S.I. No. M20-38

**SERVICE INSTRUCTION**

**SUBJECT:** REPLACEMENT OF INSTRUMENT LIGHT  
CONTROL ASSY

**AFFECTED:** M20C, Serial Numbers 20-1186 thru 20-1226  
M20F, Serial Numbers 22-1246, 22-1306 thru 22-1435  
M20J, Serial Numbers 24-0001 thru 24-0070

WIRING SCHEMATIC - S.I. M20-38-1

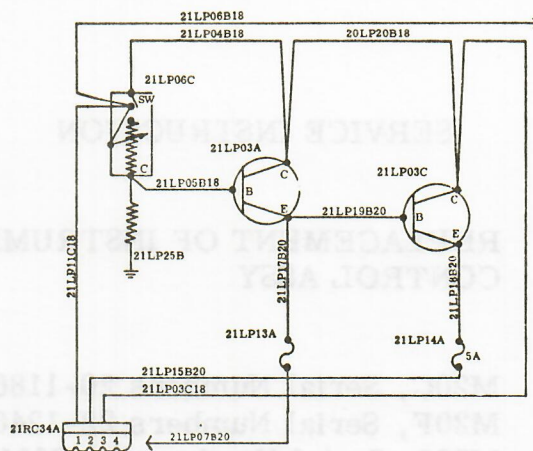
1. Loosen glareshield and raise high enough to permit access to top of radio panels.
2. Loosen (R. H.) radio panel and pull out at top to provide access to rheostat and transistor bracket.
3. Disconnect plug and (2) knife disconnects from rheostat and transistor bracket.
4. Remove light control knob and nut attaching rheostat to radio panel.
5. Drill out (3) existing rivets holding transistor bracket to radio panel.
6. Add (2) countersunk holes to radio panel per Figure #1.
7. Install light control assy (800331-928) with (2) AN507-632R5 screws and reinstall rheostat and knob in radio panel per Figure #3.
8. Reconnect plug and (2) knife disconnects per S.I. M20-38-1 wiring schematic.
9. Reinstall radio panel and glareshield.

WIRING SCHEMATIC - S.I. M20-38-2

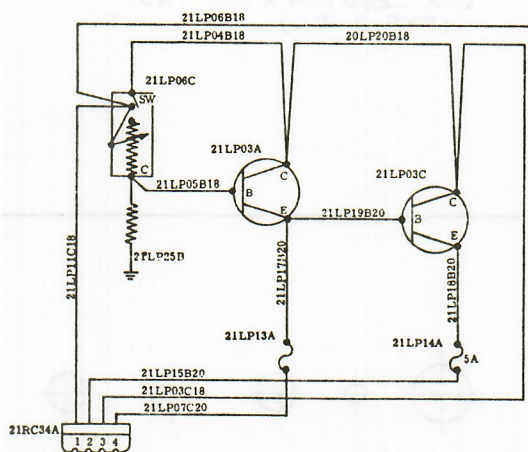
8. Reconnect plug and knife disconnect per S.I. M20-38-2 wiring schematic.
9. Reinstall radio panel and glareshield.

FIGURE #2 (J MODEL)

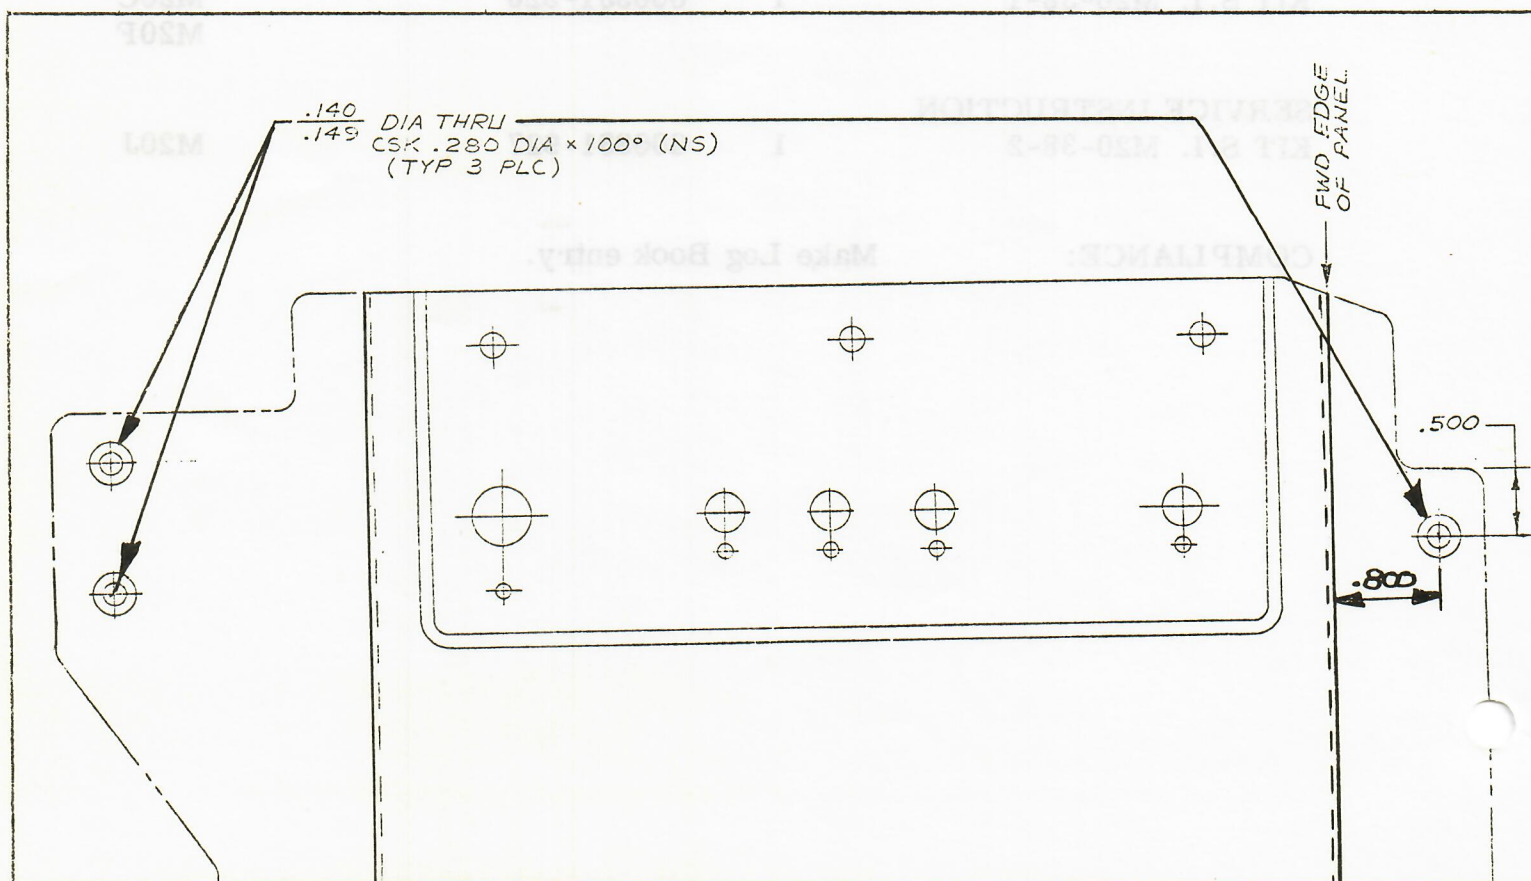
3. Disconnect plug and knife disconnect from rheostat and transistor bracket.
4. Remove light control knob and nut attaching rheostat to radio panel.
5. On aircraft S/N 24-0001 thru 24-0040, drill out (2) existing rivets and remove transistor bracket. Drill out and countersink (2) existing holes and add (1) countersunk hole per Figure #2.

6. On aircraft S/N 24-0041 thru 24-0070 remove (2) screws holding transistor bracket to radio panel and add (1) countersunk hole per Figure #2.
7. Install light control assy (800331-927) with (3) AN507-632R5 screws and reinstall rheostat and knob in radio panel per Figure #4.
